**Final
Supplemental Remedial Investigation/Feasibility Study
Work Plan Addendum**

**For the
Magna Metals Site
Lightron Corporation**

**Town of Cortlandt
Westchester County, New York**

**NYSDEC Comments
and
Mutually Agreeable Responses**

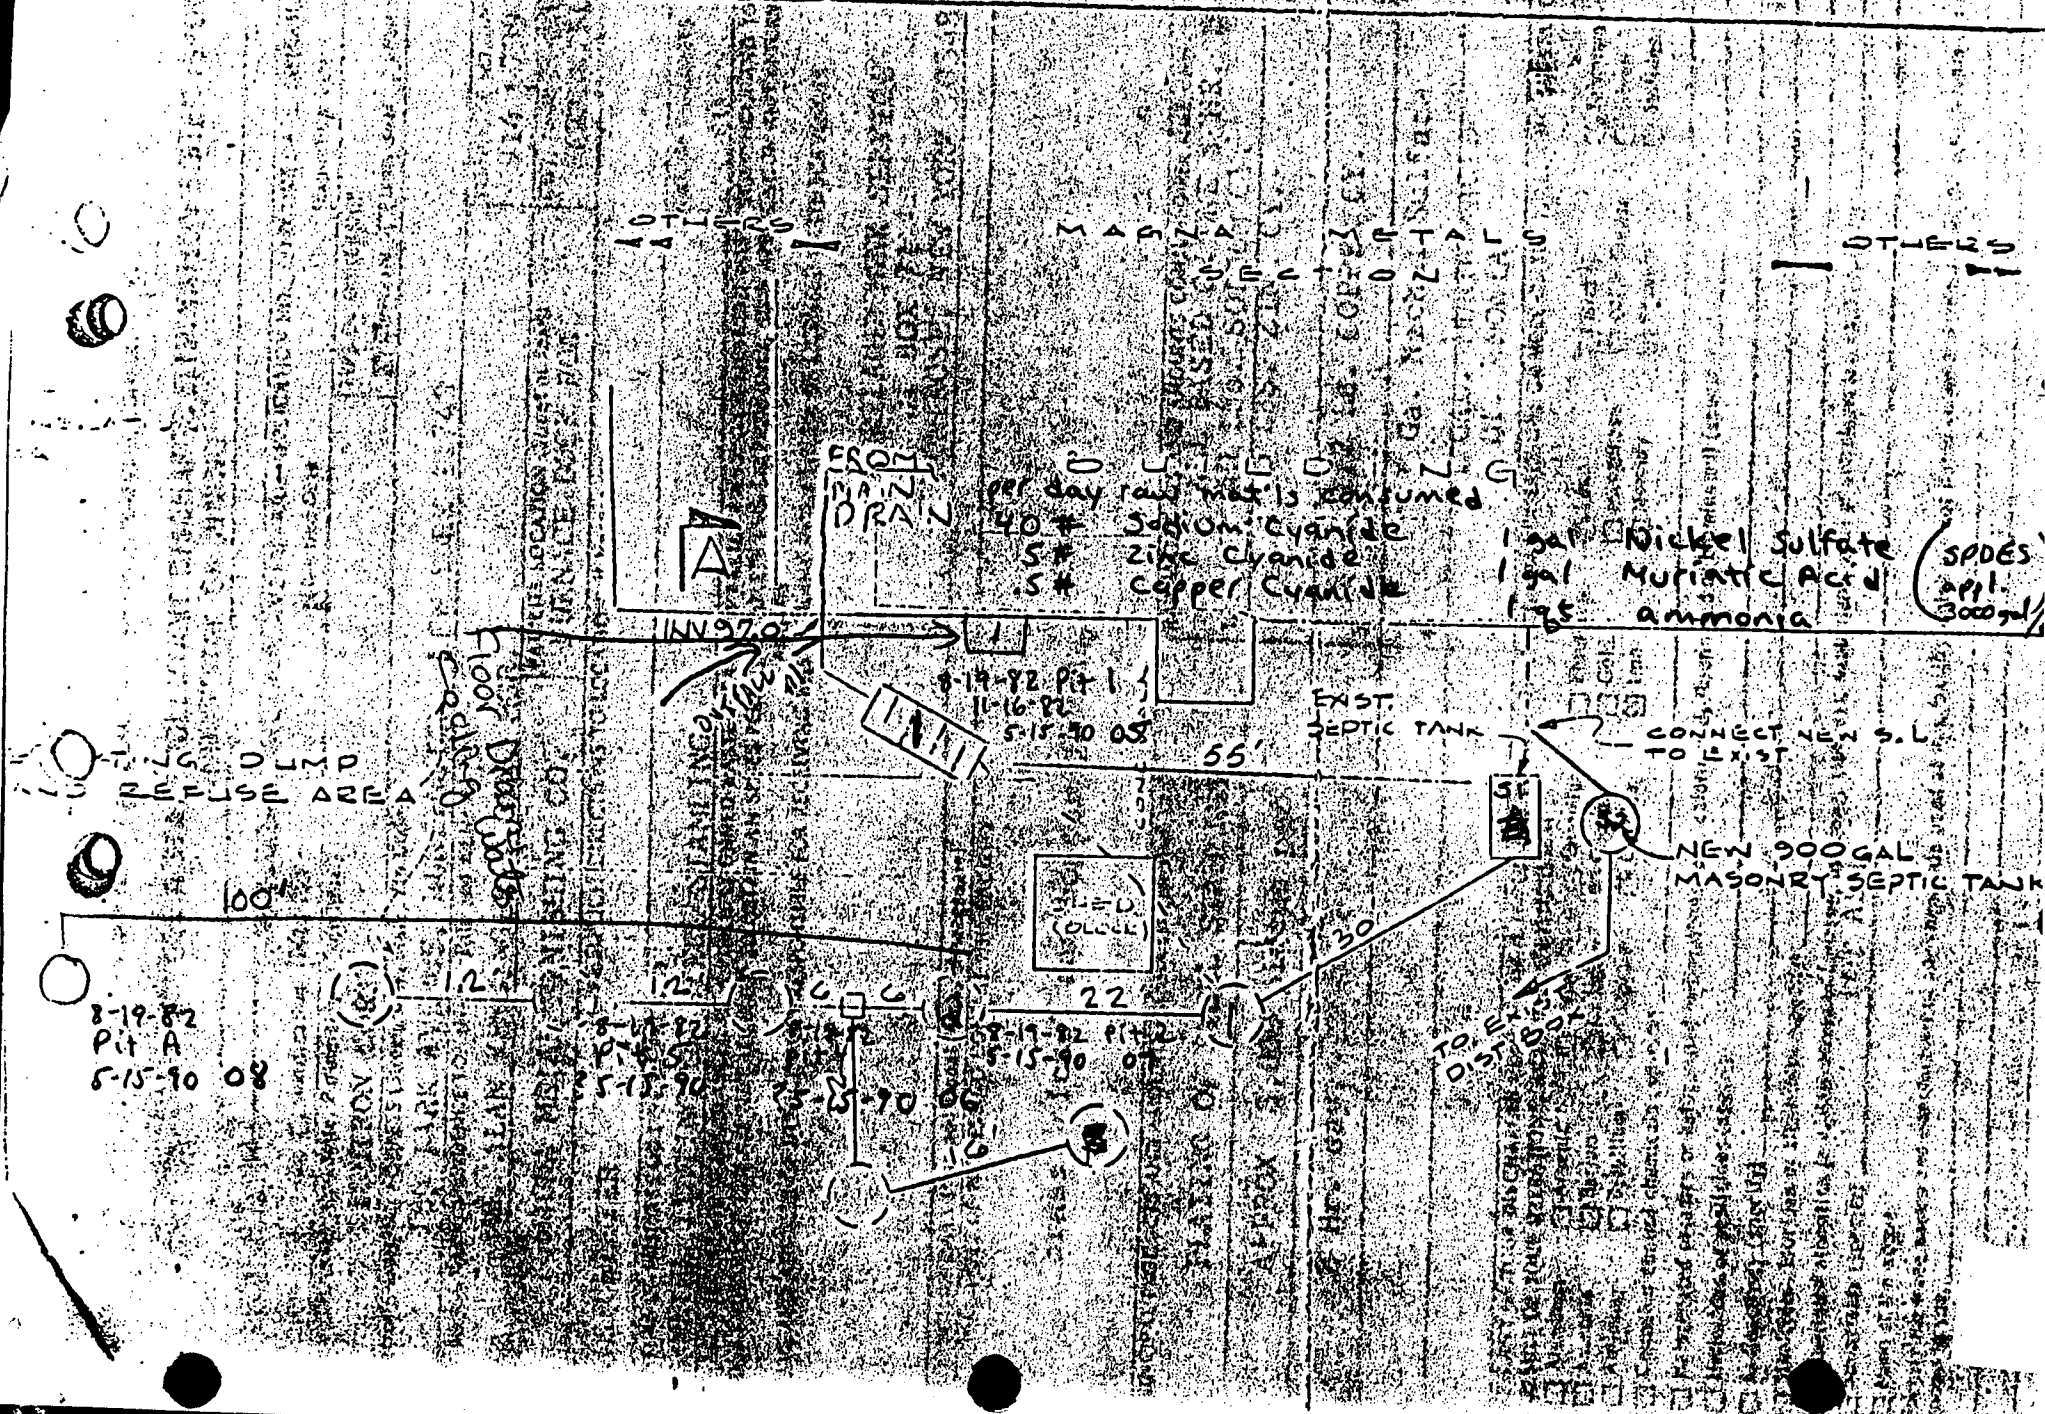
1. The area shown on Figure 1 depicting where geophysical work is to be done is not large enough. One of the figures contained in my letter to you dated September 6, 2002 shows a pit 155 feet to the west of the building. The area shown on Figure 1 does not extend that far. Another figure in the September letter shows a pit northwest of the building. These areas need to be investigated. The refuse area 100 feet west of the building shown in one of the figures in the September letter also needs to be investigated.

Upon receipt and review of the documentation provided in the September 6, 2002 letter, taking an additional effort to fully define the source area is regarded as a reasonable technical approach. The search for additional pits shall extend further to the west than previously investigated. From the maps provided, it is estimated that the search will approximately extend an additional 75 feet to the west.
